UNIVERSITY & RIDGE ADDITION WICHITA, SEDGWICK COUNTY, KANSAS

RE: SUB 2003-05 -- One-Step Final Plat of University and Ridge Addition

CASE NUMBER: SUB 2003-05 -- UNIVERSITY AND RIDGE ADDITION

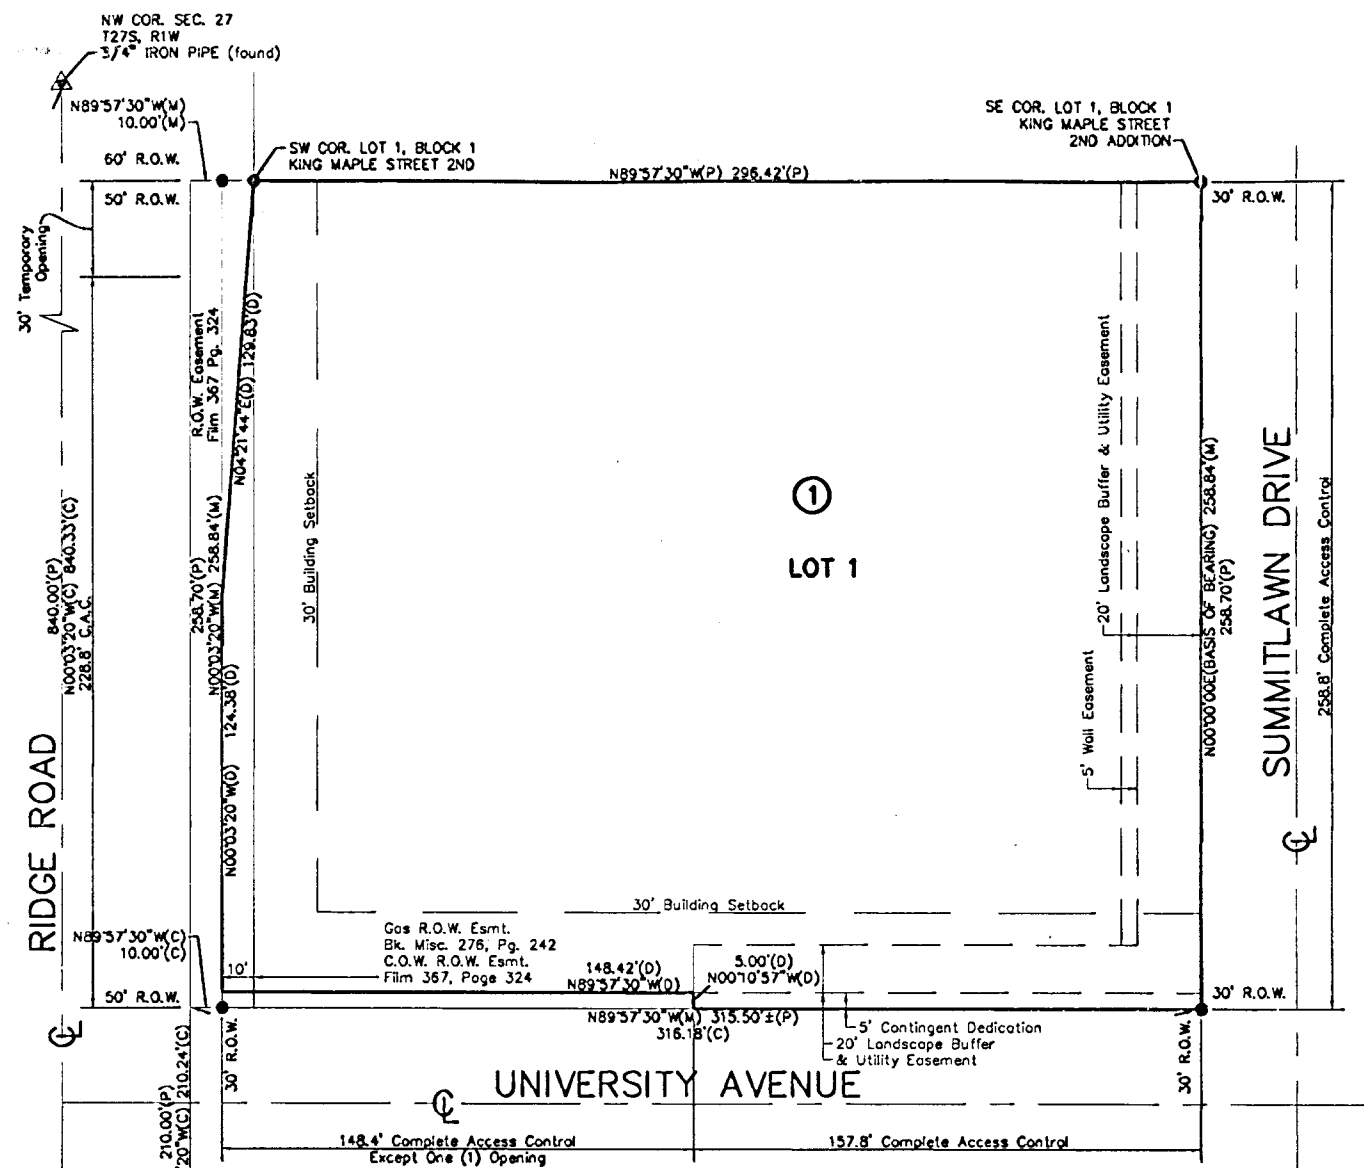
- A. Municipal services are available to serve the site.
- B. A utility easement needs to be platted for the existing sanitary sewer line and electric line.

- D. **City Engineering** needs to comment on the status of the applicant's drainage plan. **The drainage plan needs revised. A private stormwater extension will be needed at time of site development.**

- E. The plat proposes one access opening along both Ridge Road and University along with a 15-ft contingent opening along the north property line. A cross-lot access easement was approved for the property to the north (King's Maple Third Addition) through a 30-ft opening for the benefit of this property. Distances should be shown for all segments of access control. **One opening along University is approved although no left turns out are permitted. A 30-ft temporary opening along Ridge at the north property line is approved which shall be closed when an adjoining opening to the north is constructed. A cross-lot access agreement with the property to the north shall be provided that grants access rights to the owner of this plat within the west 50 feet of the property to the north.**

- F. **Traffic Engineering** has requested the dedication of 10 feet of additional right-of-way along Ridge Road to conform with the 60-ft half-street right-of-way required by the Access Management Regulations.

- G. **Traffic Engineering** has requested an additional 5 feet of right-of-way along University Avenue. The Subdivision Regulations require a 70-ft half-street right-of-way for a commercial street. **A 5-ft contingent dedication has been platted for a portion of this right-of-way which has been approved.**

- K. **County Surveying** has requested a precise location for the benchmark.
- L. The legal description needs revised to delete the language "being replatted as...".

- M. The applicant is reminded that in addition to the wall easement platted parallel to the east property line, the Protective Overlay also required a wall constructed parallel to the south property line.

- A. Municipal services are available to serve the site.
- B. A utility easement needs to be platted for the existing sanitary sewer line and electric line.

- D. **City Engineering** needs to comment on the status of the applicant's drainage plan. **The drainage plan needs revised. A private stormwater extension will be needed at time of site development.**

- E. The plat proposes one access opening along both Ridge Road and University along with a 15-ft contingent opening along the north property line. A cross-lot access easement was approved for the property to the north (King's Maple Third Addition) through a 30-ft opening for the benefit of this property. Distances should be shown for all segments of access control. **One opening along University is approved although no left turns out are permitted. A 30-ft temporary opening along Ridge at the north property line is approved which shall be closed when an adjoining opening to the north is constructed. A cross-lot access agreement with the property to the north shall be provided that grants access rights to the owner of this plat within the west 50 feet of the property to the north.**

- F. **Traffic Engineering** has requested the dedication of 10 feet of additional right-of-way along Ridge Road to conform with the 60-ft half-street right-of-way required by the Access Management Regulations.

- G. **Traffic Engineering** has requested an additional 5 feet of right-of-way along University Avenue. The Subdivision Regulations require a 70-ft half-street right-of-way for a commercial street. **A 5-ft contingent dedication has been platted for a portion of this right-of-way which has been approved.**

- K. **County Surveying** has requested a precise location for the benchmark.

- L. The legal description needs revised to delete the language "being replatted as...".
- M. The applicant is reminded that in addition to the wall easement platted parallel to the east property line, the Protective Overlay also required a wall constructed parallel to the south property line.
